National Committee on Uniform Traffic Control Devices
TECHNICAL COMMITTEE RECOMMENDATIONS TO SPONSORS

TECHNICAL COMMITTEE: Regulatory/Warning Signs Technical Committee

TOPIC: Horizontal Alignment and Advisory Speed Warning Signs

**AFFECTED PORTIONS OF MUTCD: Sections 2C.06 Thru 2C.11, 2C.36 and 2C.46;
Table 2C-5; Figures 2C-1, 2C-5 and 2C-7**

Revised Figure 2C-5. Speed Reduction Signs

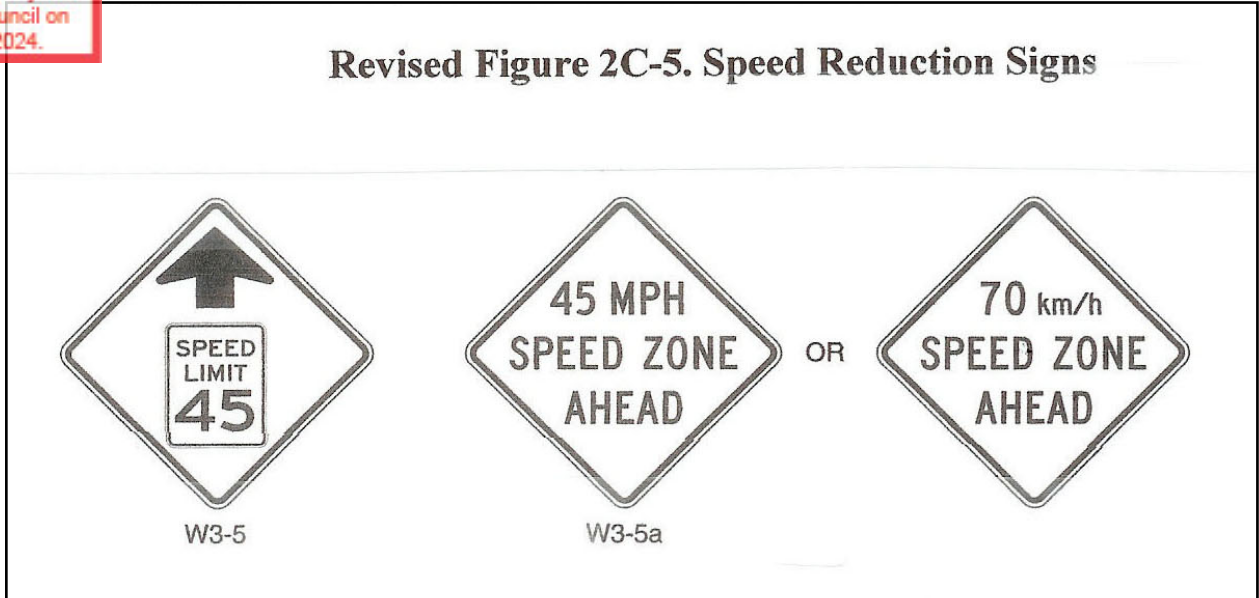
Revise ~~Figure 2C-5, Advisory Speed and Speed Reduction Signs~~, by relocating the
Advisory Speed signs to Figure 2C-1. Note that the Advisory Curve Speed (W13-5) sign
has been deleted.

Figure 2C-7. Example of Advisory Speed Signing for an Exit Ramp, to illustrate the addressed in Section 2C.13 and 2C.14.

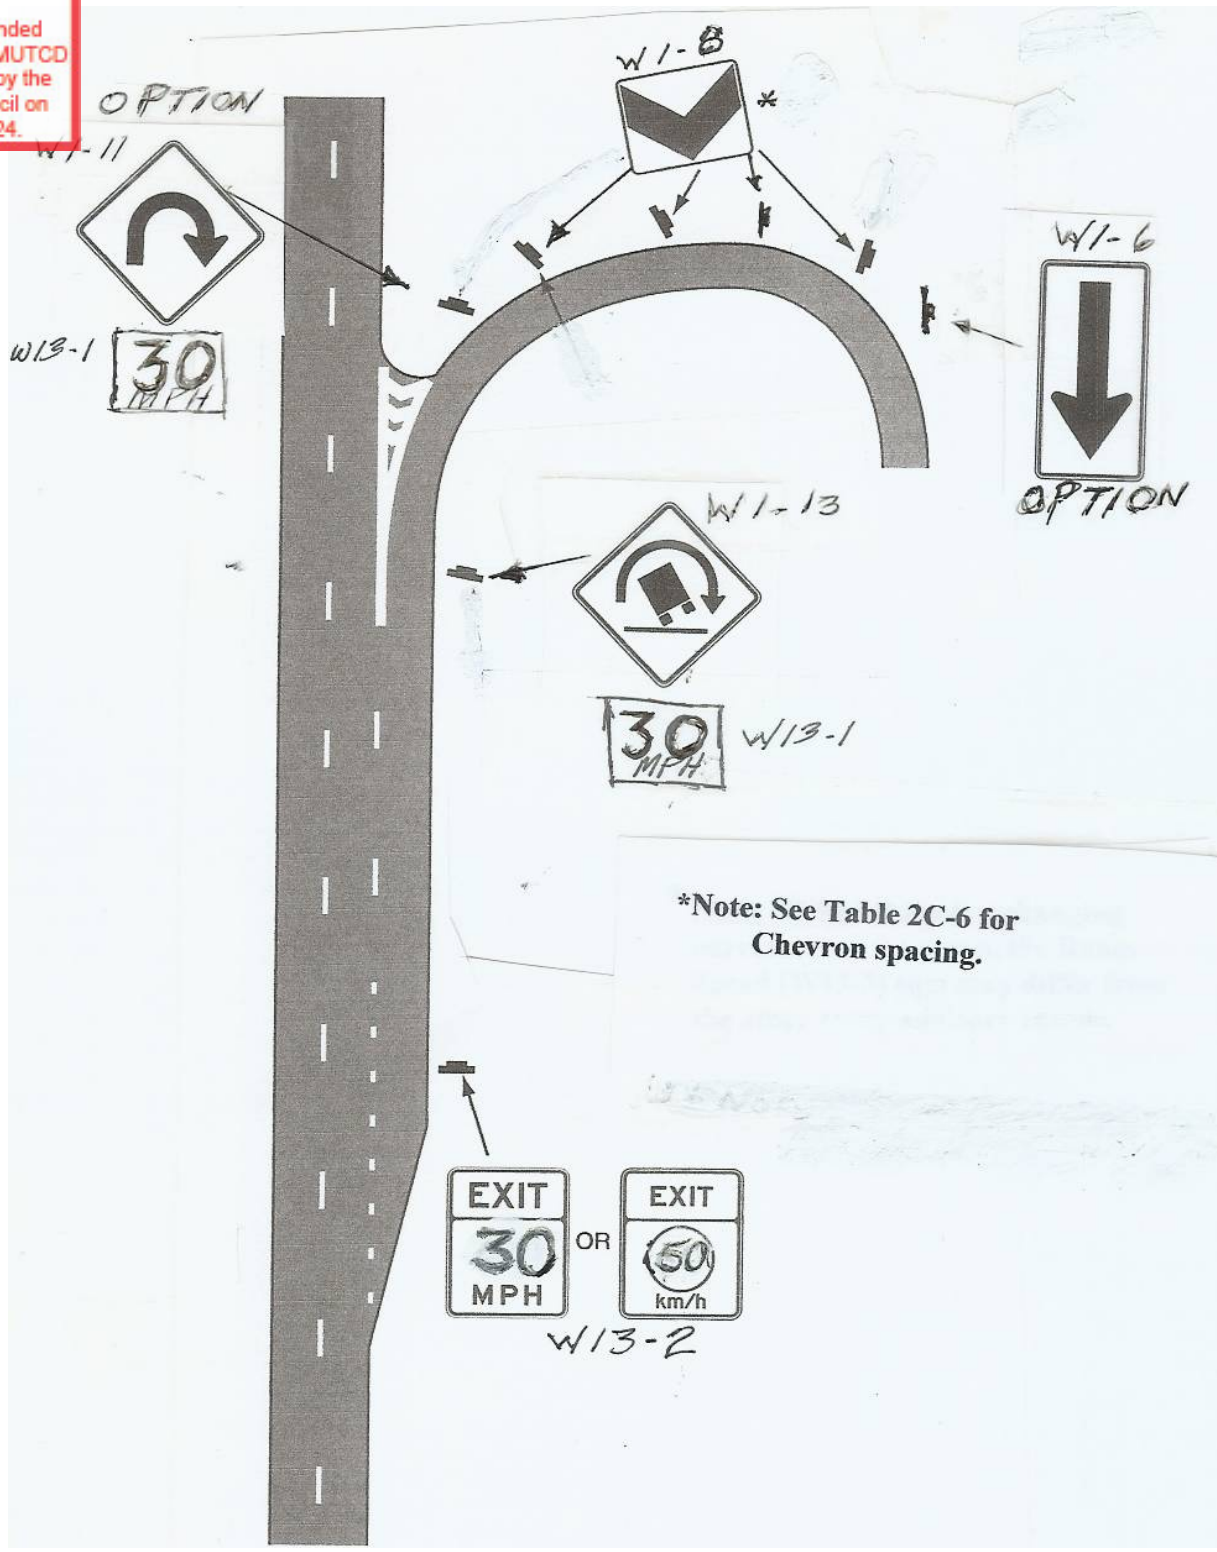
Figure 2C-7 has been revised to provide a better example of Exit Speed, Ramp Speed and Truck Rollover Warning signs.

Revise
signing
**RESCINDED
JANUARY 2024**
This Recommended
Change to the MUTCD
was rescinded by the
NCUTCD Council on
January 12, 2024.

Figure 2C-X. Example of Warning Signs for a Turn

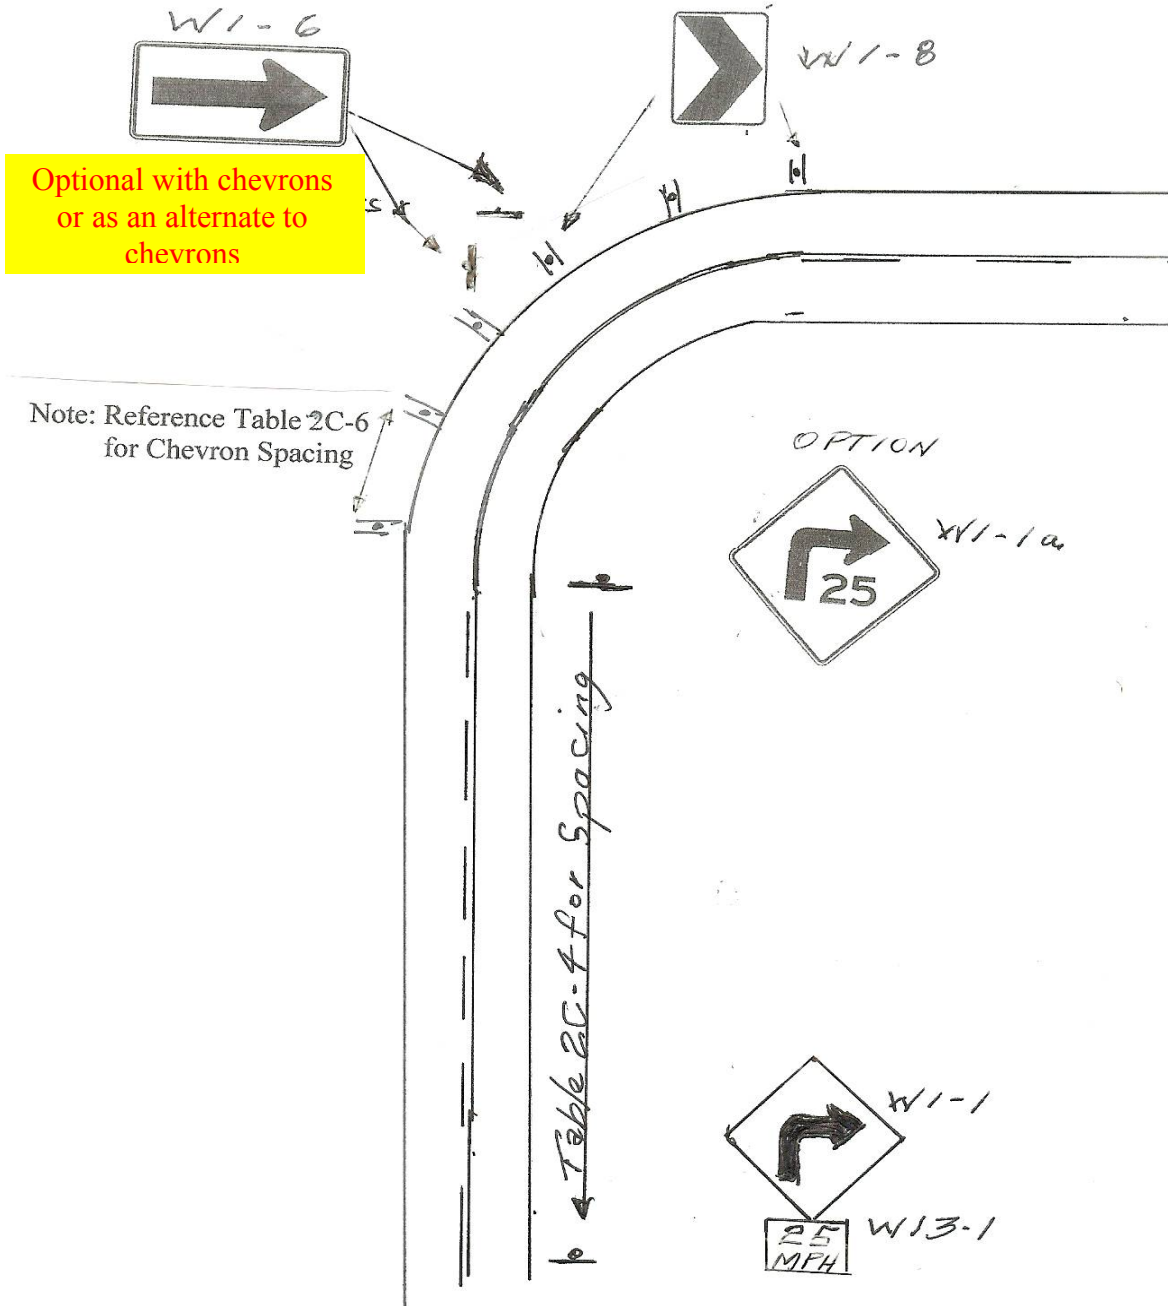
Figure 2C-X has been added to provide an example of signing and markings for a turn including clarification of optional provisions.

new Figure 2C-X. Example of Signing for a Turn to illustrate the application of optional signing addressed in Sections 2C.07, 2C.09, 2C.10 and 2C.12.
